SUBJECT: MINUTES OF OUR NOVEMBER 30, 1982 MEETING WITH CP&L
ON THE USE OF RAYCHEM-FLAMTROL CABLES

SUBJECT: SAFETY EVALUATION FOR ENVIRONMENTAL QUALIFICATION OF
SAFETY-RELATED ELECTRICAL EQUIPMENT

Re: Brunswick Steam Electric Plant, Units 1 and 2

EQUIPMENT ENVIRONMENTAL QUALIFICATION REVIEW OF EQUIPMENT ITEM NO. 164

Table 1 Test Specimens

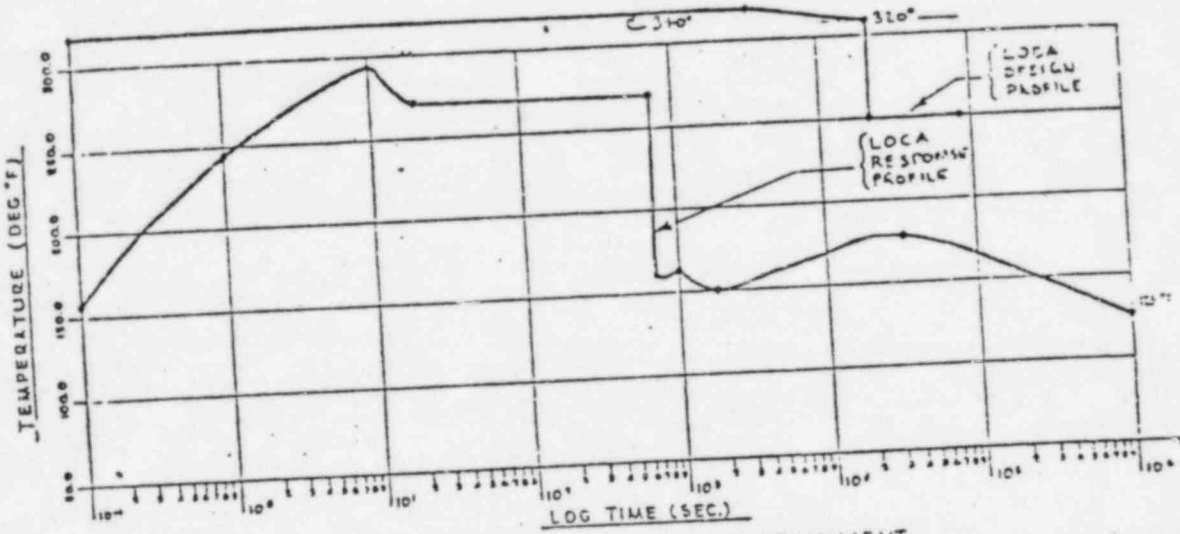
The licensee has not identified the cable characteristics (such as jacket and insulation thickness) which would establish the applicability of the referenced report to the installed cables. This is particularly important because certain 1000V multiconductor Flamtrol cables have been observed to have insulation properties significantly different than the cables tested in the referenced report (F-C4033-1). Of particular concern was a tendency of conductor insulation to experience dielectric breakdown at voltage levels considerably below those expected for polyethylene cable. Total insulation thickness (i.e. cable jacket plus conductor insulation) and cross linking electron beam energy used during fabrication are believed to be critical parameters.

The licensee should provide the information on the cable insulation thickness (jacket and conductor insulation) and any other characteristics which demonstrate that the installed cable is the same as the cable in the referenced test.

TEMPERATURE TRANSIENT INSIDE CONTAINMENT PROFILE "A"

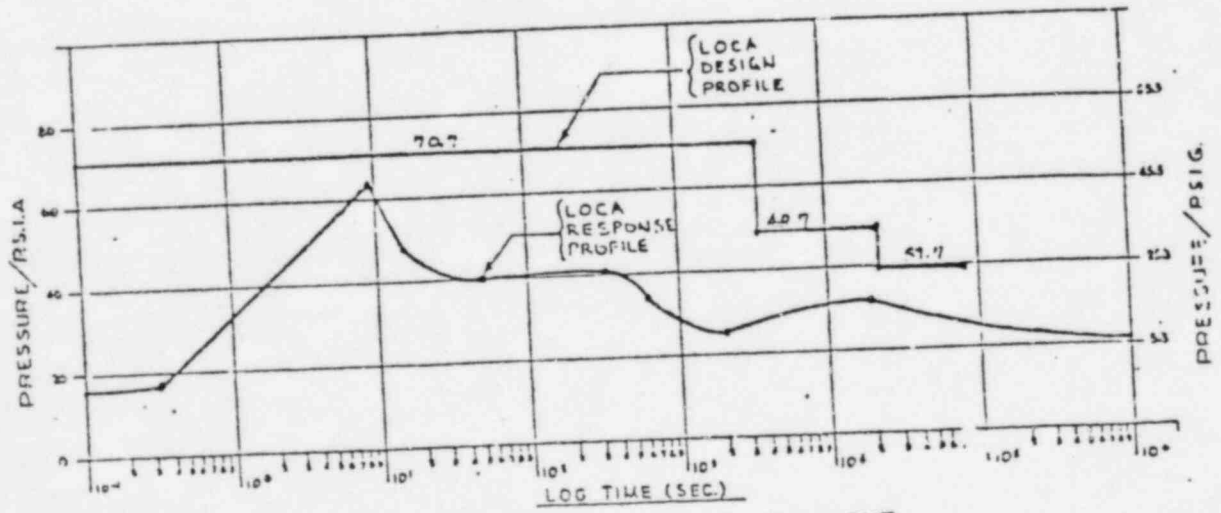
THE TEST PROFILE ENVELOPES THE ACCIDENT PROFILE BY A WIDE MARGIN
